**NRC Staff's Answer to
Entergy's Motion to Dismiss Contention RK-EC-8
(Endangered and Threatened Species) as Moot (Aug. 6, 2013)**

NUREG-1437, Supplement 38, Vol. 4 (June 2013)

2.0 IMPINGEMENT AND ENTRAINMENT DATA CORRECTIONS

Figure 4-3. Percentage of entrainment composed of RIS fish and total identified fish relative to the estimated total entrainment at IP2 and IP3 combined (data from Entergy 2007b)

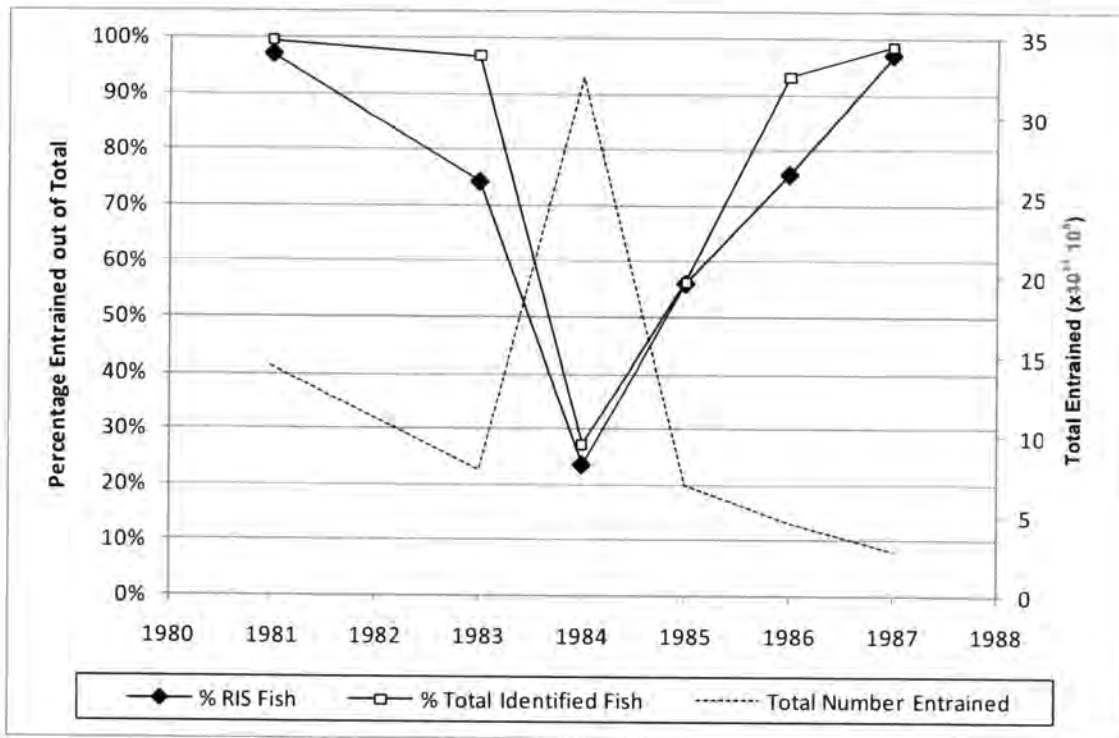
In the FSEIS, the NRC staff estimated the number entrained for a given week as the product of the mean density entrained and the combined weekly flow for IP2 and IP3. The error in the entrainment catch density directly affects Figure 4–3 in Section 4.1.2, and the error is repeated in Figure H–5 in Appendix H. In these figures, the total number entrained on the right axis should be in units of numbers $\times 10^8$ instead of numbers $\times 10^{11}$. The corrected Figures 4–3 and H–5 appear below. In addition, these changes affect two portions of text in the FSEIS.

Figure 4–3 on page 4-15 in the FSEIS is corrected as follows:

Figure H-5. Percentage of entrainment composed of RIS fish and total identified fish relative to the estimated total entrainment at IP2 and IP3 combined (data from Entergy 2007b)

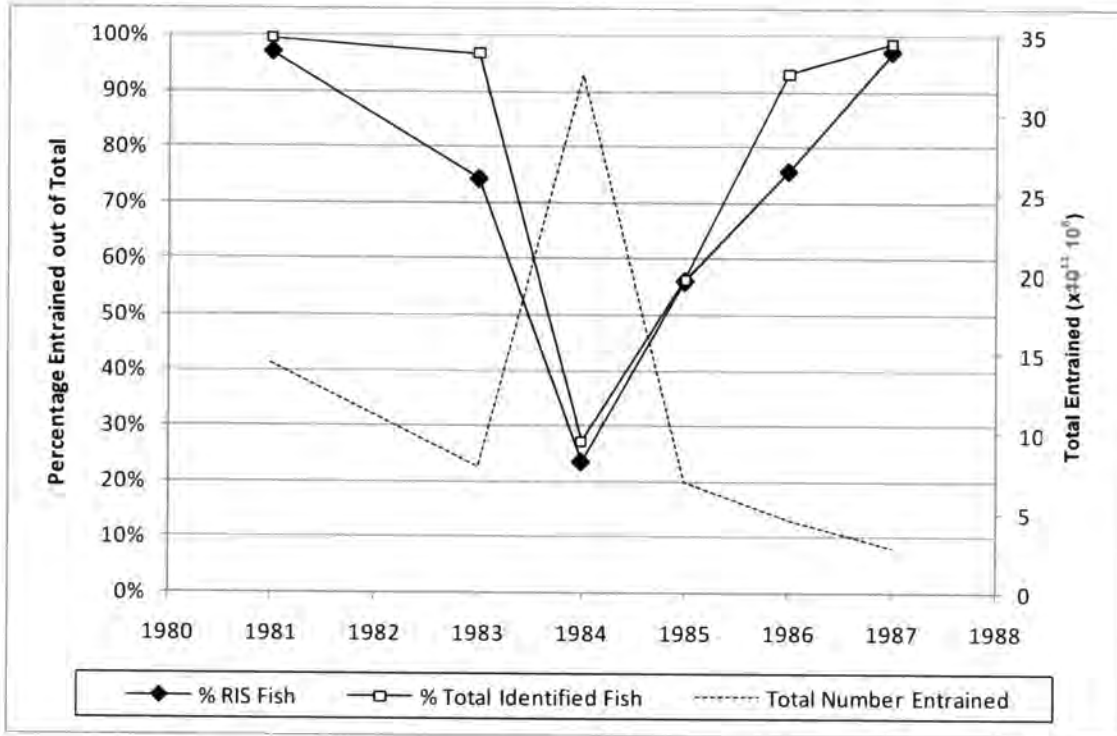
Figure H-5 on page H-23 in the FSEIS is identical to Figure 4-3 in the FSEIS and is corrected as follows:
